Service Bulletin

Bulletin No.: PIT6452E

Subject: Poor Heater Performance On Drivers OR Passengers Side

7020910

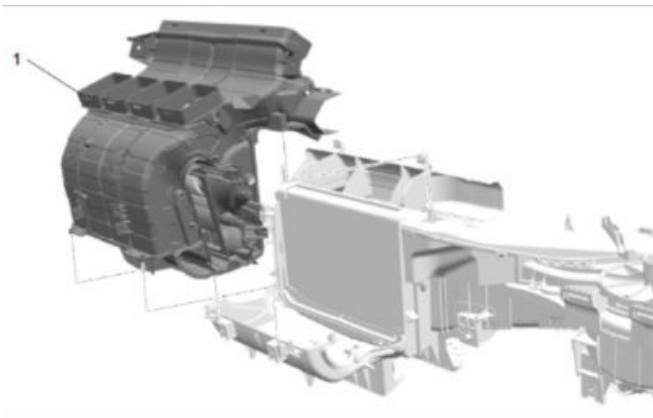
- Access the view through the upper vents or the HVAC evaporator temperature sensor openings.
- Using a borescope, inspect for a disconnected temperature door link. (Note: The mode will have to be set to the vent position, and you will have to enter at the center dash vent for the affected side.)
- Move both the driver's and passenger's temperature doors through their full range of travel while monitoring with the borescope.
- Watch for any binding or resistance that may cause the white temperature door link to separate from the doors or produce a popping noise.

If any door exhibits these symptoms, proceed to Step 2.

If all doors operate correctly, follow the standard SI diagnostic procedure.
